PUBLIC HEARING MEMORANDUM

SUBJECT: **Petition #317-19**, for SPECIAL PERMIT/SITE PLAN APPROVAL to allow Single-Family Attached Dwellings with waivers to the dimensional standards and to allow a retaining wall exceeding four feet within the setback at **67 Walnut Street**, Ward 2, Newtonville, on land known as Section 21, Block 24, Lot 15, containing approximately 14,520 sq. ft. of land in a district zoned MULTI RESIDENCE 1. Ref: Sec. §3.2.4, §3.4.1, §5.4.2.B, §6.2.3.B.2, §7.3.3, and §7.4 of the City of Newton Rev Zoning Ord, 2015.

MEMORANDUM

Re: Special Permit – #67 Walnut Street

Proposed Zoning Plan

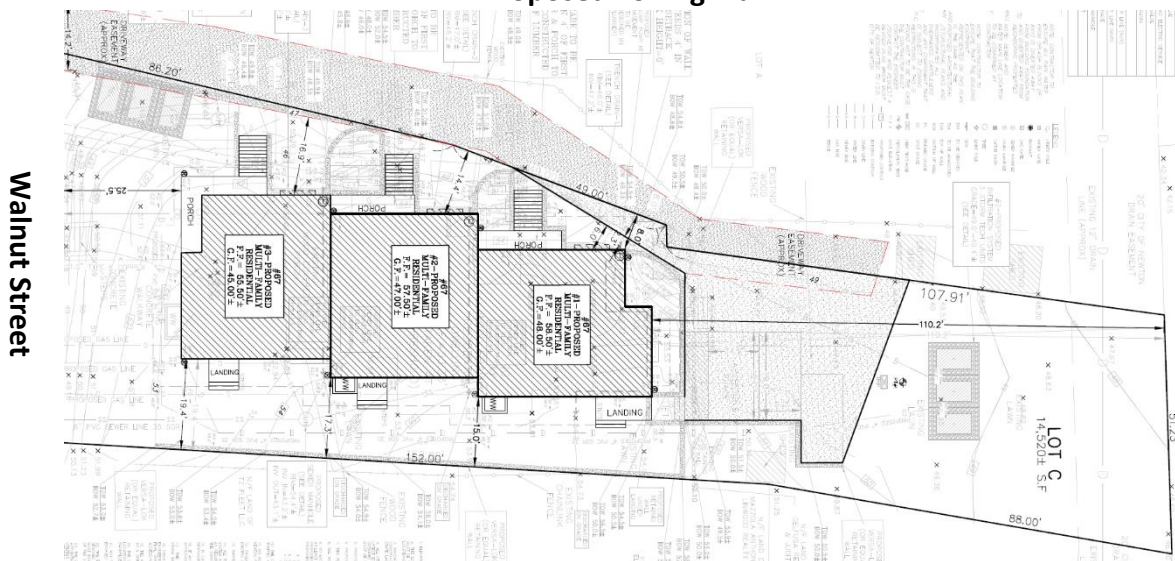
Access to the Attached Dwellings will be maintained in the form of the shared driveway providing access to three one-car garages in the basement of each unit, and a three-stall surface parking facility at the rear. The petitioner is proposing to install a retaining wall along the northern boundary that will be approximately 113 feet long, varying from .5-foot tall to 5.5-foot tall along its length. The petitioner is proposing additional retaining walls along the southern façade to allow for the garage entrances and the front porches. Several of these walls are four feet tall and are within the side setback.

aisle. The petitioner provided a turning template demonstrating how vehicles will enter and exit the garages, but staff suggests that the template be overlaid on the site plan to fully demonstrate the maneuvers.

Existing Common Driveway

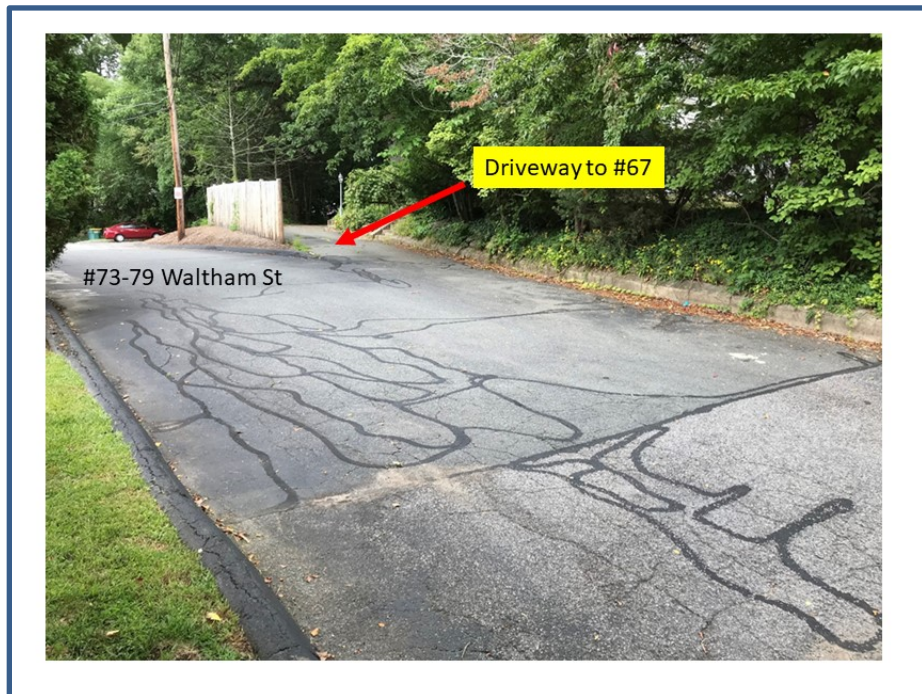
A drainage collection system is shown on the site plan, however; no drainage report or soils evaluation was provided for comment. One of the infiltration systems is to be located immediately along the southern property line, the City requirement is a minimum of 10-feet from any abutter, this needs to be relocated, any units less than 10-feet also need to have an impervious barrier along its perimeter to prevent breakout of stormwater.

The design also has a system located in the rear of the lot to infiltrate water from sump pumps. The engineer needs to provide calculations on the sizing of the system based on the amount of groundwater that is expected to be encountered and pumped to this system. The City does not have a standard for modeling groundwater; therefore, design assumptions shall be provided by the engineer of record.

The proposed sanitary sewer alignment is acceptable except that the service connection from unit #3 as proposed has a reverse flow condition [i.e. flowing upstream], therefore the manhole must be shifted a minimum of 10-feet towards the street to provide proper flow.

The Director of Utilities would prefer that one domestic service connection of adequate size be installed to the development and then sub-metered rather than having three individual services installed, additionally the three services as shown run under several retaining walls which is unacceptable. Finally, a 1" copper service is labeled as a fire suppression service, this seems very undersized, fire flow testing and hydraulic calculations are needed to justify the 1-inch fire suppression line.
